# Seattle Design Commission

## Approved MINUTES OF THE MEETING

15 December 2005

South lake Union Streetcar  
Mercer Corridor Project  
Broadview Library Expansion

#### **Sub stations**

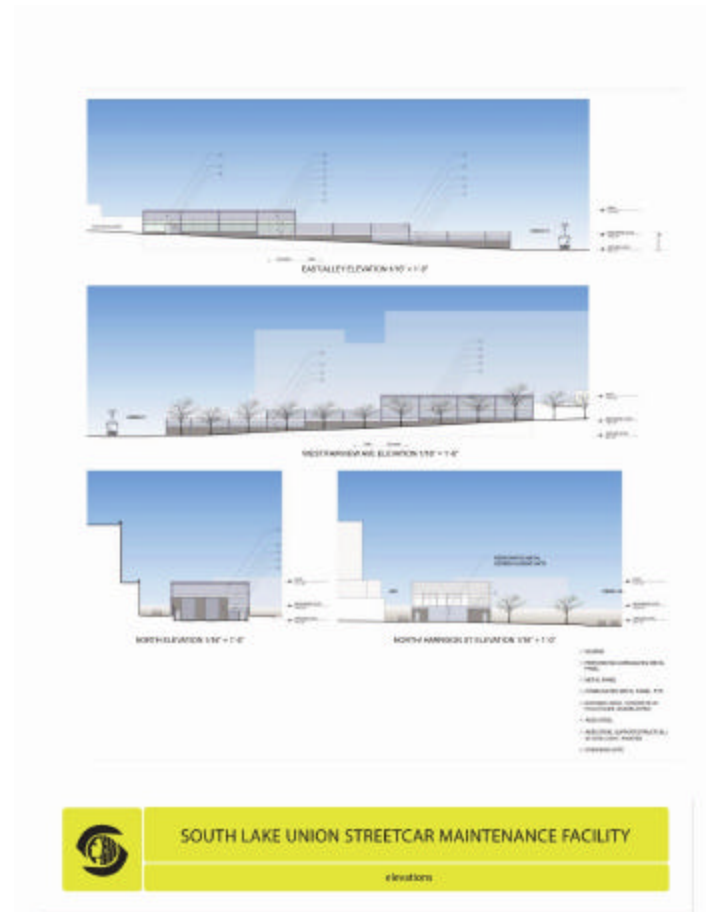
- **are concerned about a couple of the sub stations, particularly the north triangle, on the west side of Fairview and strongly encourages the team to consider putting it underground. If this is truly not an option, the Commission urges the design team to focus more on aesthetics and integrating the building into the neighborhood fabric.**

- Vigorously dislikes the idea of an above ground substation. Feels it will be an eyesore to the neighborhood and disapproves of using the art budget towards hiding it.
- Is concerned that an above ground substation, in the right of way, contrasts with the principles behind the rest of the project.
- Recommends artist involvement in developing the system identity for the street car program
- Suggests that the Maintenance facility offers educational facilities
- Feels that the cars and system can be elegantly designed, independent of an art project, allowing the art program to focus on a different part of the project.

- Three substations are still required
  - Southern substation – below ground at the triangle
  - Middle substation – below ground at block 40 in the alley.

- Northern substation – above ground
- Metro requires an above ground access.
- The substations will be 10’ wide, 12’ long and 12’ high.
- The above ground substation will be integrated into the neighborhood.

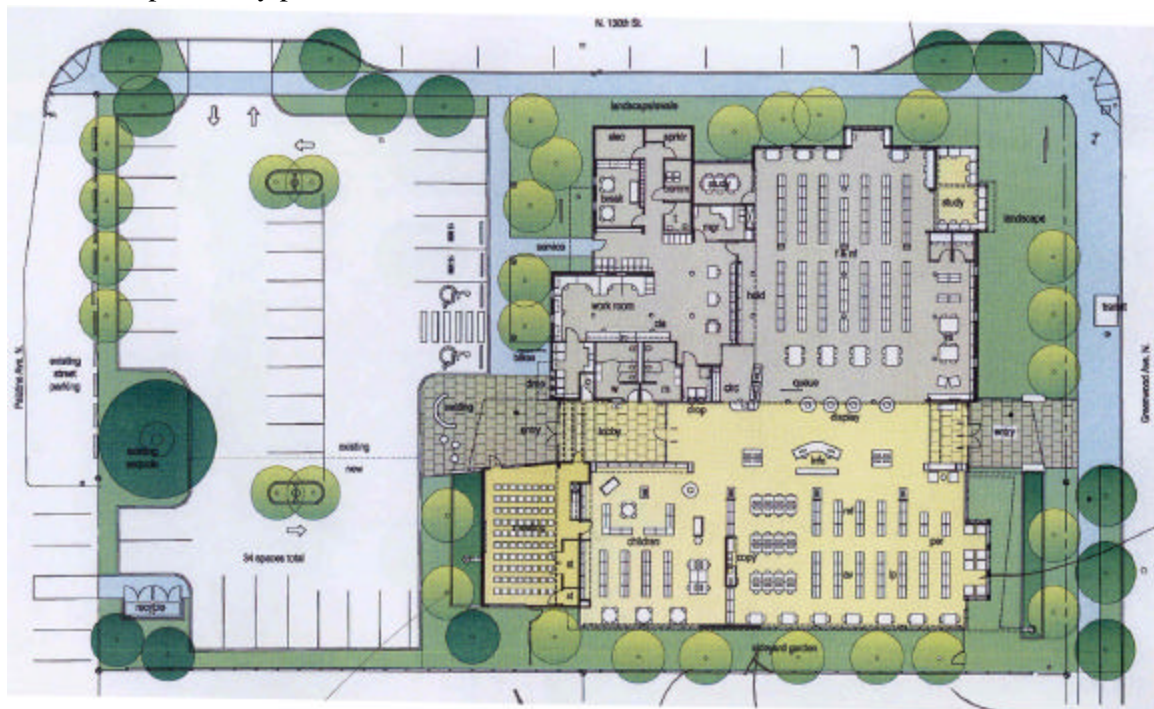
- **hopes the height of the windows along the south side of the community room will continue to be studied as they may need to be dropped a few inches. The Commission also urges the proponents to revisit the interior layout of the lecture, storage and meeting rooms.**

- Endorses the use of the storm water planters but feels they should extend both sides of the entrance.
- Approves of experience created by the South wall when seated, but is concerned about the height of the screen from a standing position.
- Questions why the roofs only overhang on the East and West.
  - These directions suffer from the most glare
  - The site boundary on the south restrict the extrusion
- Commend the evolution of the design, especially the landscaping
- Reiterates the approval of the reading room lantern
- Feel the entrances work well, highlight the two different buildings while successfully joining them together.
- Feels that the design is very interesting since it takes on a different form
- Feels the lecture room is still unresolved
- Advocates for sustainable design practices as much as possible

1. the south wall of the building is part screen and part window, looking out to lacy vegetation, and evergreen ground cover, which buffers the fence.
